**ADDENDUM
NO. 5**

**Perry Meridian High School Phase 1 – Student Activity Center
401 W. Meridian School Road
Indianapolis, IN 46217**

PROJECT NUMBER: 24173P

S011

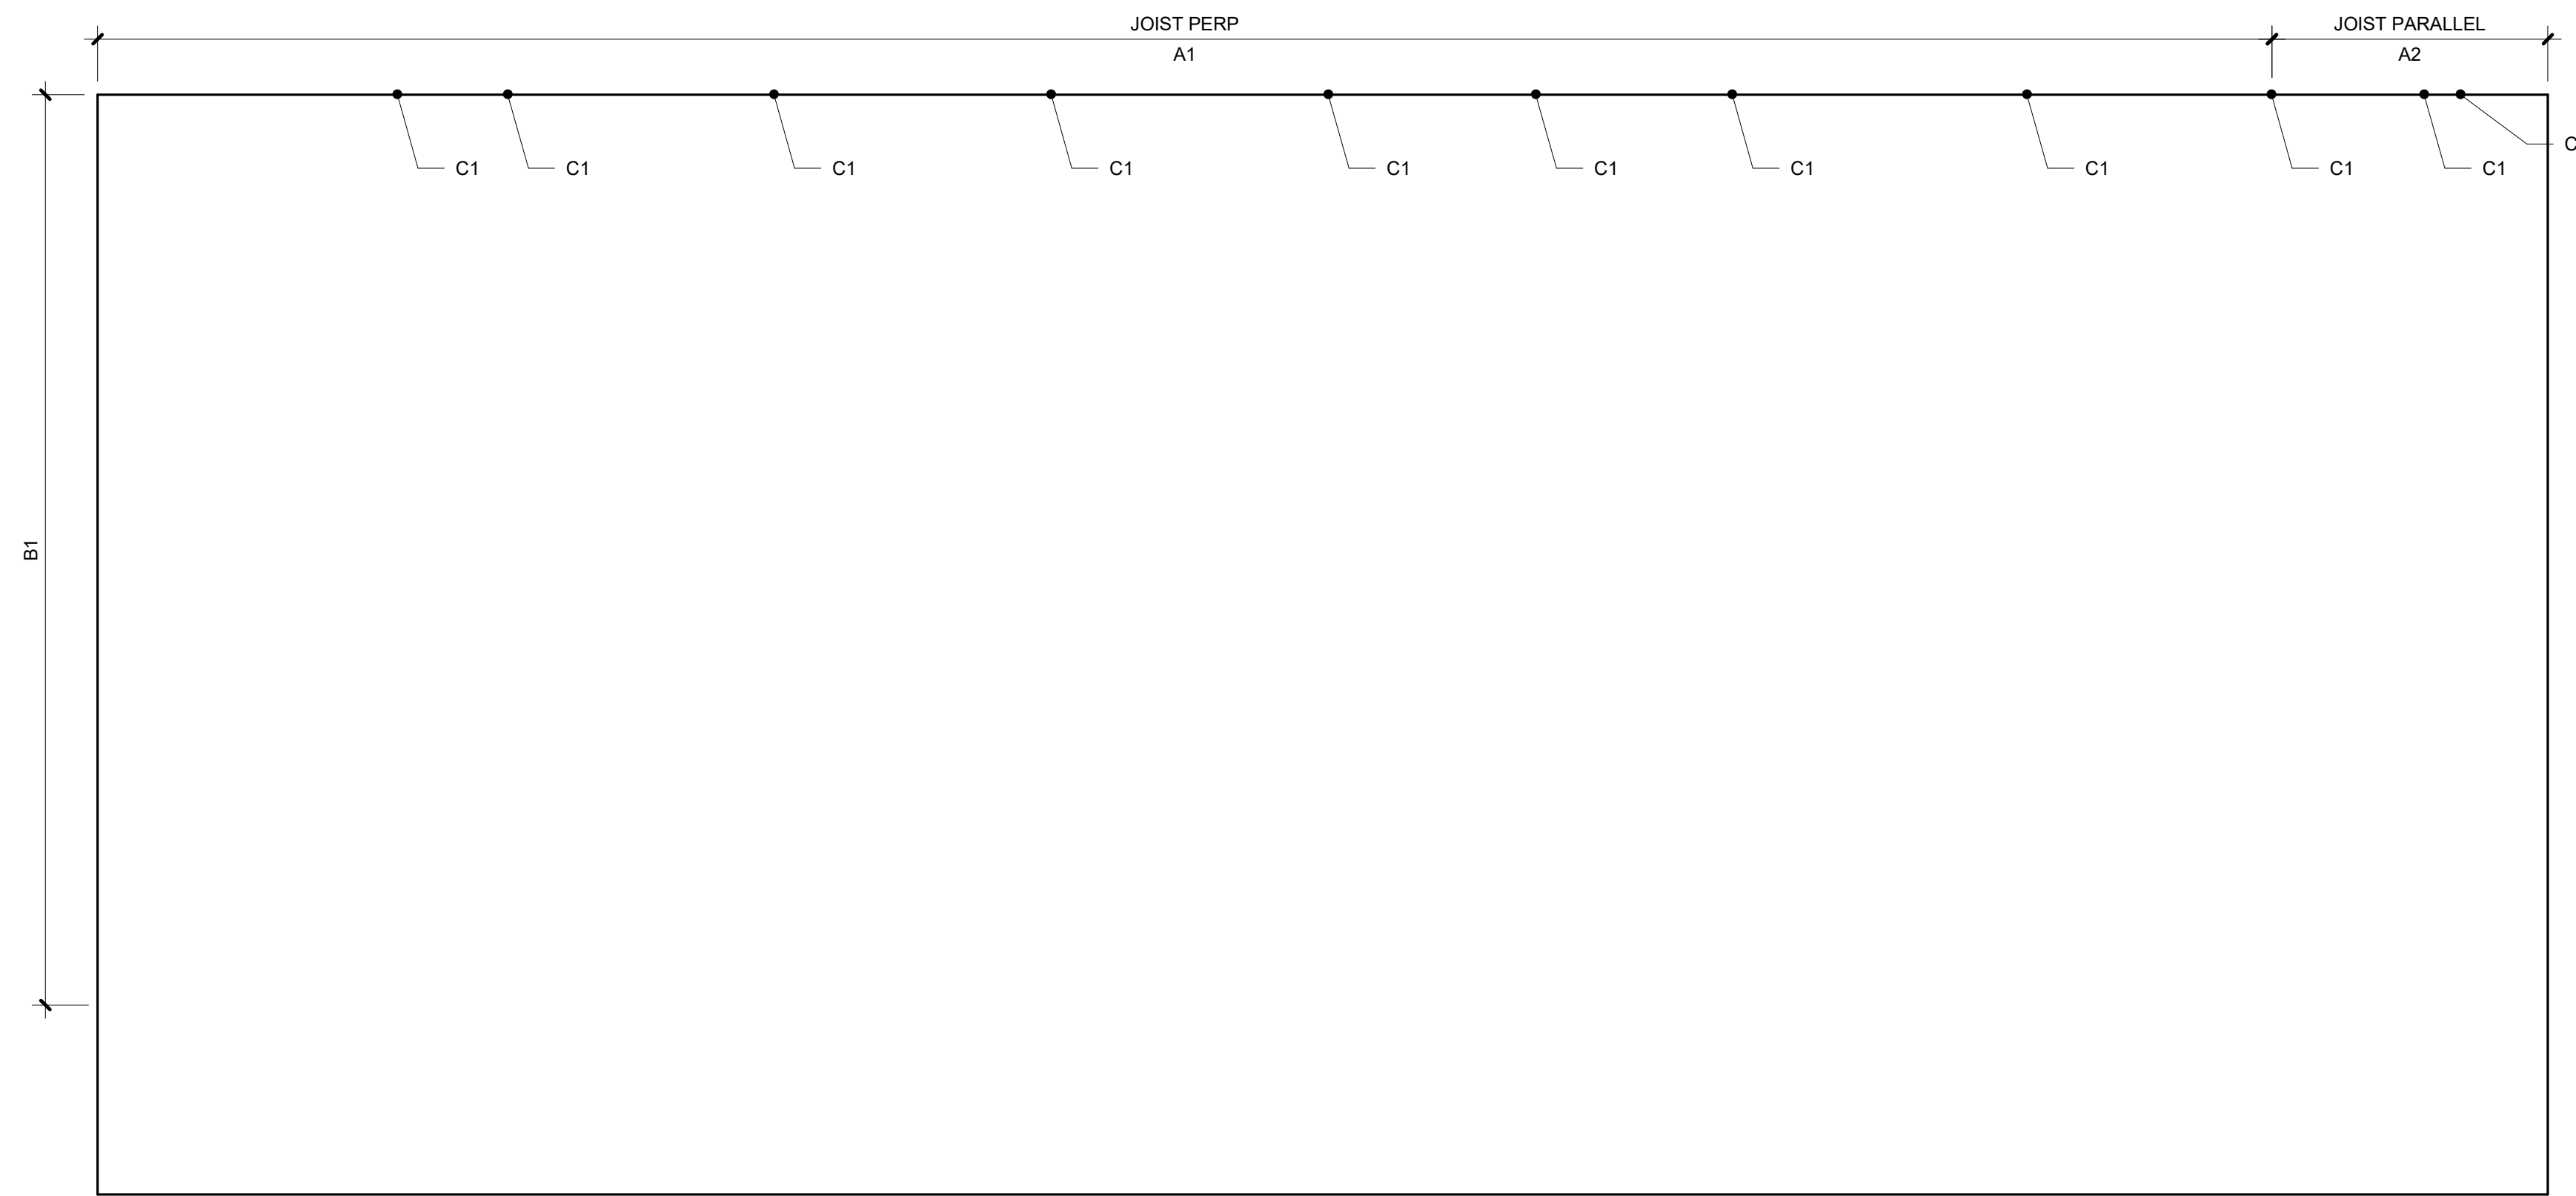
1. Drawing Sheet Number: S011
Drawing Sheet Title: LOAD MAPS

Change: Revised annotation.

- Revised loading and notes.
